STANDARDISATION OF NOSE RADOMES

## ENGINEERING INSTRUCTION

EI-Number: DFW B707-53-512	Rev.: 00	Date: 20 Jan, 2009
----------------------------	----------	--------------------

**Component / Equipment Type:** Standardisation of TCA Nose radomes

Glide Slope Antenna Director Bar Installation  
Figure 401

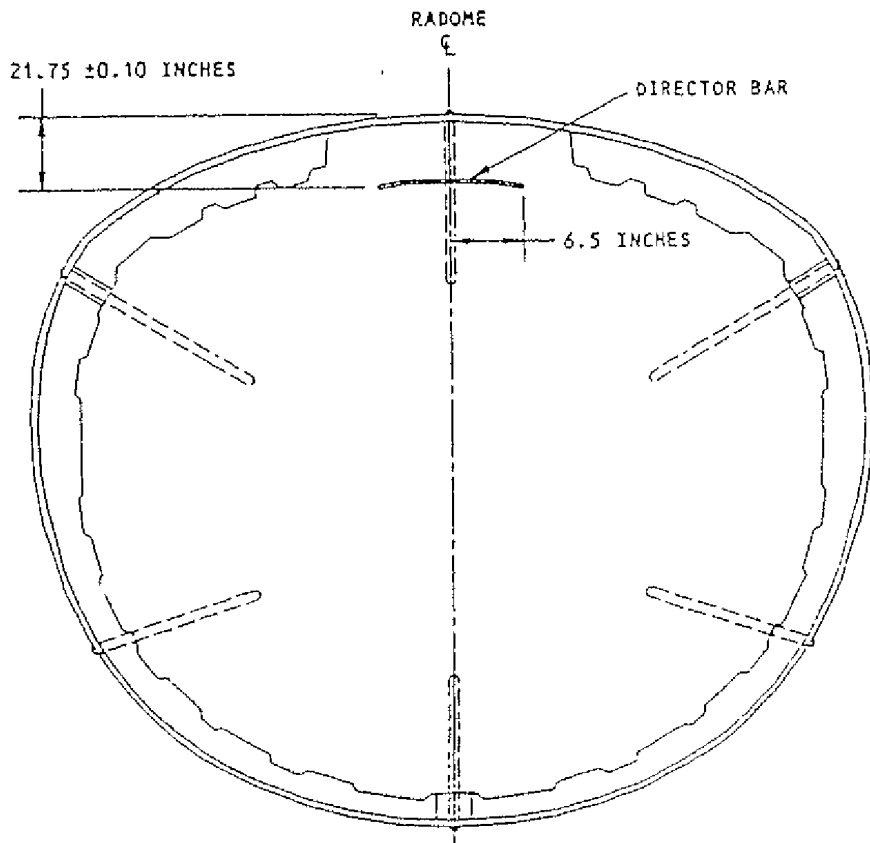
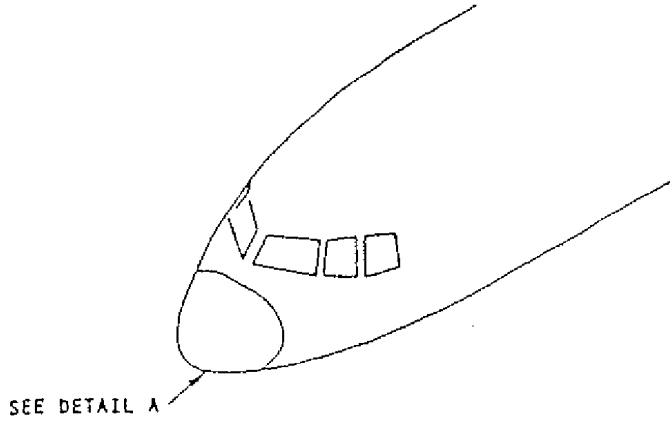
- Verify if the Glide slope antenna director bar is installed in accordance with AMM 53-2-53 page 401. Correct any location discrepancy accordingly.
- Remove glide slope antenna director bar located approx 8.2 inches away from the edge (if installed) in accordance with AMM 53-2-53 page 401.
- Identify modified nose radome with the sentence  
"modified with EI DFW B707-53-512 REV 0" per BAC5307 par 8.3.1 RA using options for rubber stamp per 8.3.2.g.
